This Service Information bulletin supersedes SI M17 06 12 **dated October 2012**.

Service Action: Retrofit of the Engine Coolant Temperature Sensor

R55

All with manual transmission and either the N14, N16 or N18 engine

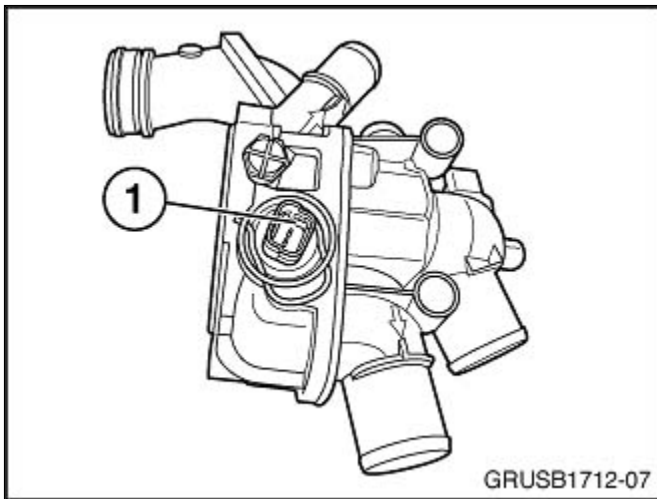
NEW **Procedure One** requires the replacement of the upper coolant hose with a modified hose that houses a new engine temperature sensor. An adapter harness needs to be fitted to the car to utilize this new sensor.

NEW Procedure Two requires the installation of a new engine temperature sensor, with integrated wire harness, installed in place of the thermostat bleeder screw.

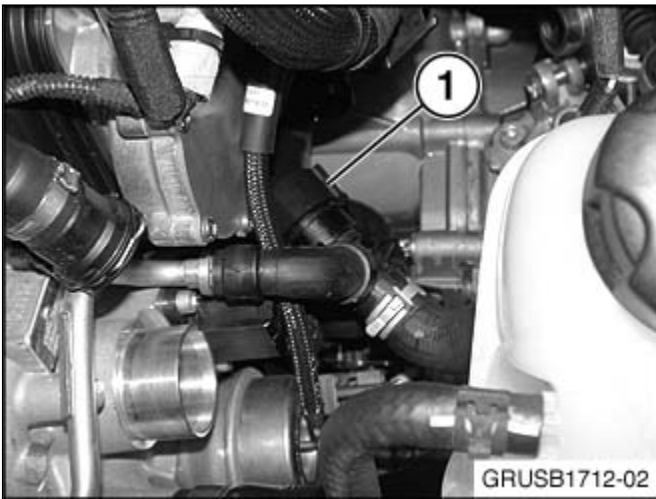
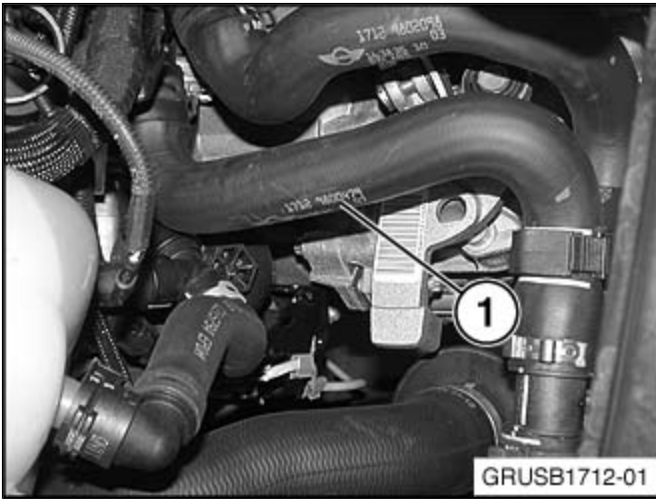
Remove the fresh air intake tube and the intake tube from the air box to the turbo to gain access to the coolant hose.

Remove the coolant hose (1). This hose will not be reused.

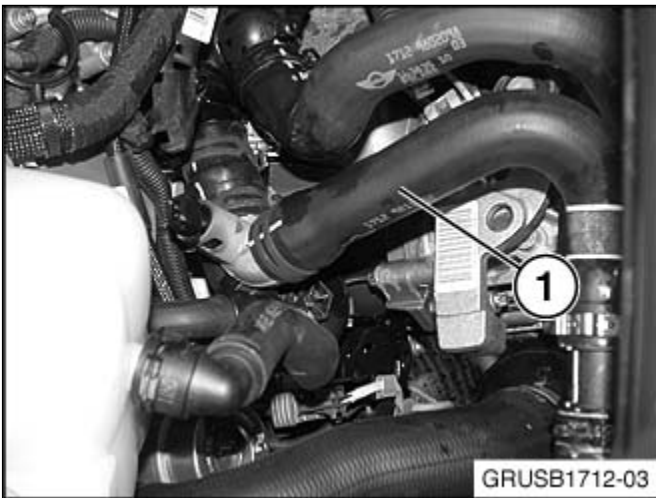
N18 engine only! Install spacer P/N 64 53 7 578 707 (1) on the coolant line as shown.

Note: The spacer needs to stay in this position when installing the new coolant hose P/N 17 12 7 647 004 (next step).

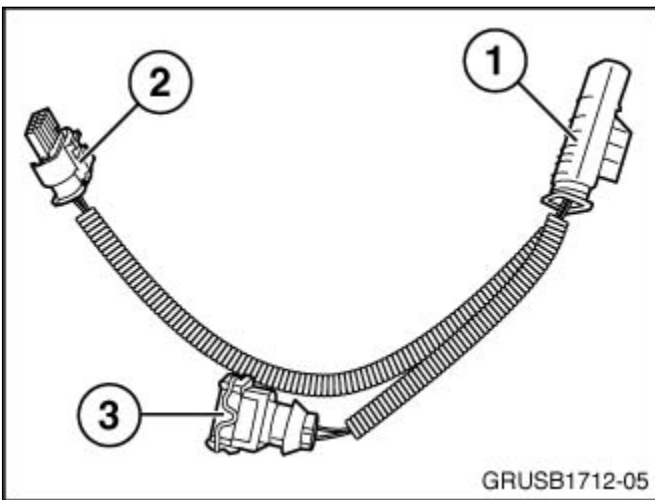
Install the new coolant hose with sensor P/N 17 12 7 647 004 (1).

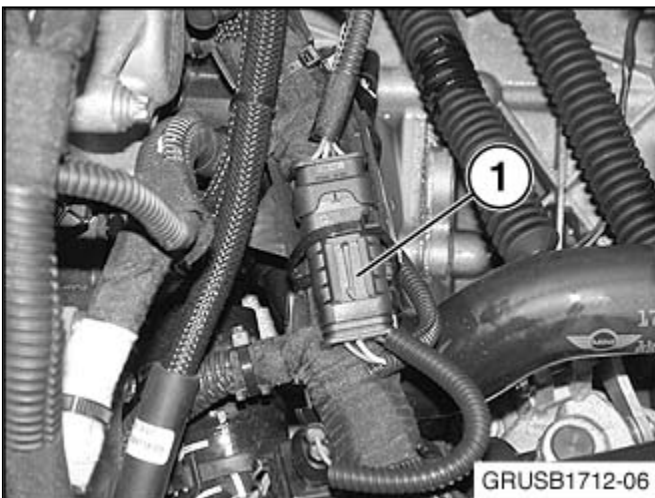
Unplug connector X6279 from the engine thermostat (1).

Plug connector X6279 into the 4-pin male connector (1) of adapter harness P/N 12 51 7 647 200. Insert the 4-pin female connector (2) of the adapter harness into the engine thermostat. Plug the 2-pin female connector (3) from the adapter harness into the engine temperature sensor of hose P/N 17 12 7 647 004.

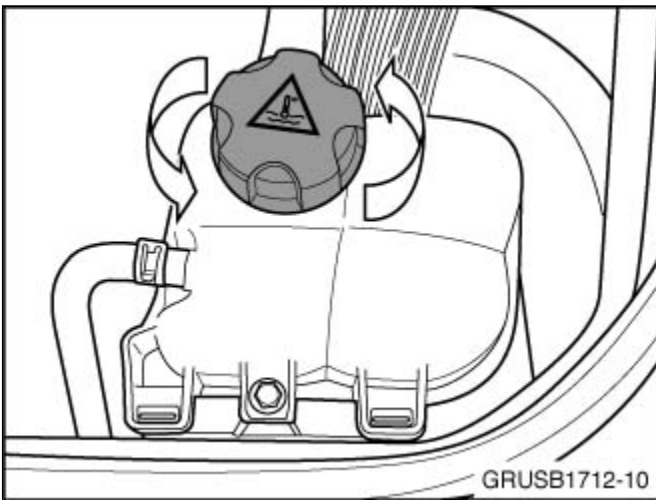
The improved sensor (P/N 13 62 8 603 908) includes the temperature probe (1) and insulating sleeve (2), a two-pin female connector (3) for the map thermostat, and a four-pin connector (4) for the engine harness.

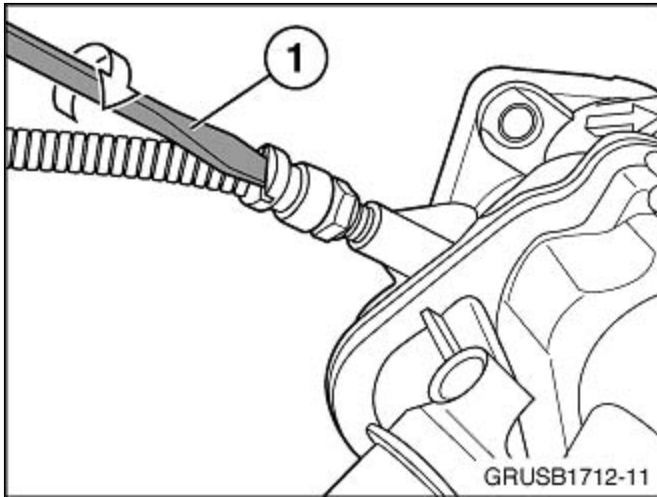
Remove the bleeder screw (1) from the thermostat. This screw will not be reused.

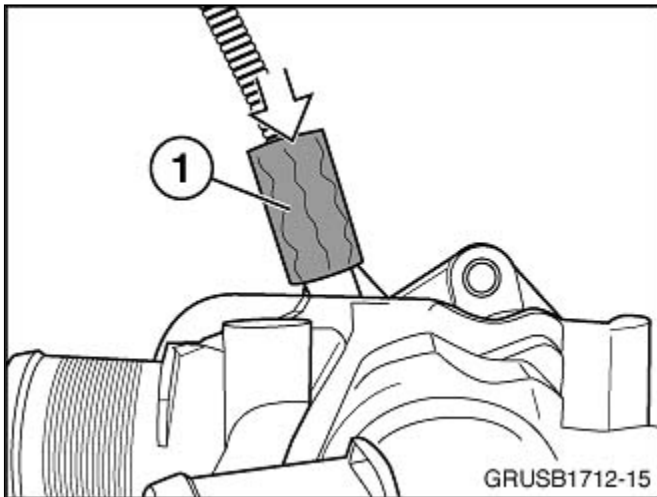
The back of the temperature sensor is slotted to accept a bladed screwdriver (1). Install the sensor into the bleeder screw hole, and torque to 2Nm.

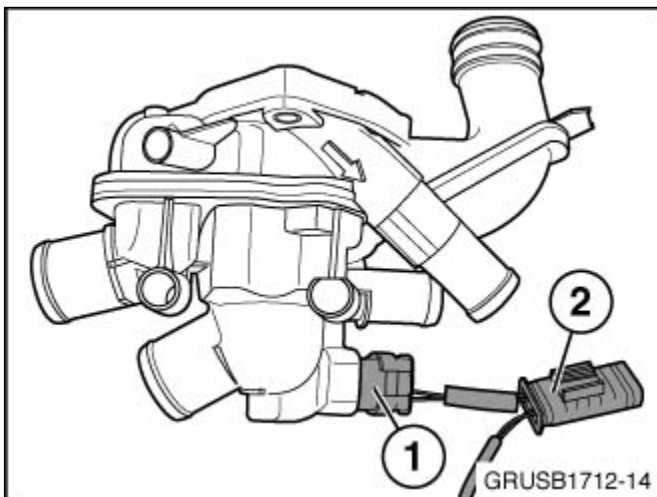
Slide insulating sleeve (1) onto the temperature sensor. The sleeve must completely cover the sensor.

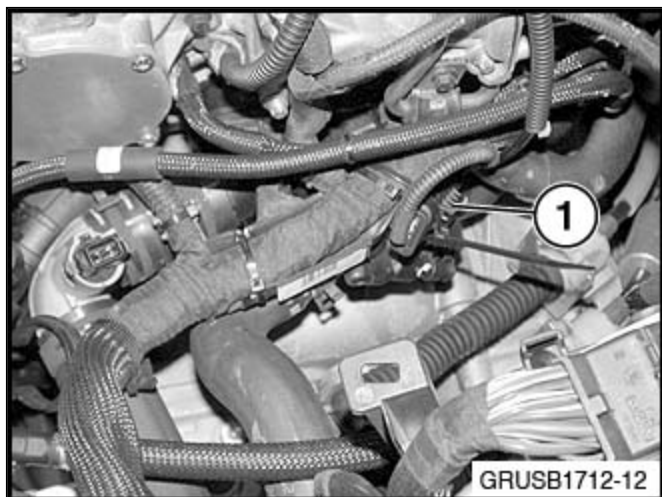
Install the two-pin female connector (1) into the thermostat and the four-pin male connector (2) into the engine wiring harness.

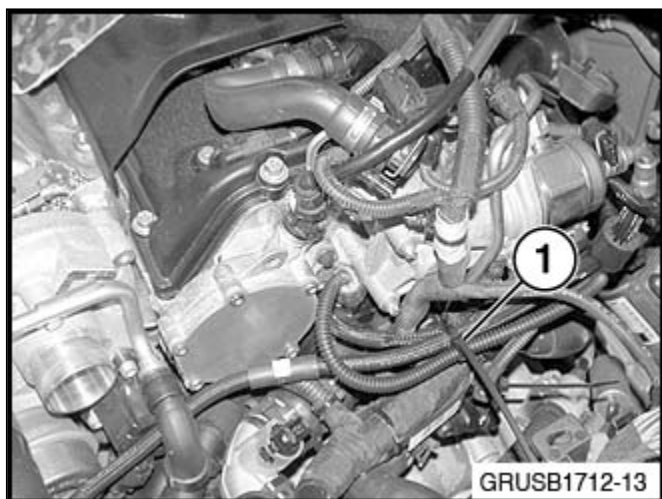
Secure the connector (1) with a cable tie to the engine wiring harness.

Secure the wiring from the temperature sensor (1) with a cable tie.
